Access Compliance Report Public Rights-of-Way (Curb Ramps)

Main Street: FAIRHAVEN_AVE Cross Street: OLYMPIA_WAY Location: SE

ADA ID: RPAT211022091405 Ramp Type: Type 6 - Directional 1 Initial Pass/Fail: Fail Overall Compliance: No Severity Score: 16

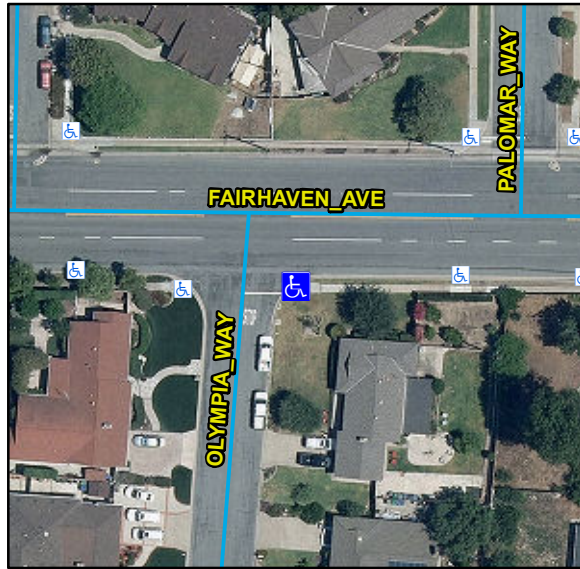
R304.2.2, R304.5.3, STD 1115

Remove & Replace Curb Ramp With Two New Directional Ramps or Equivalent.
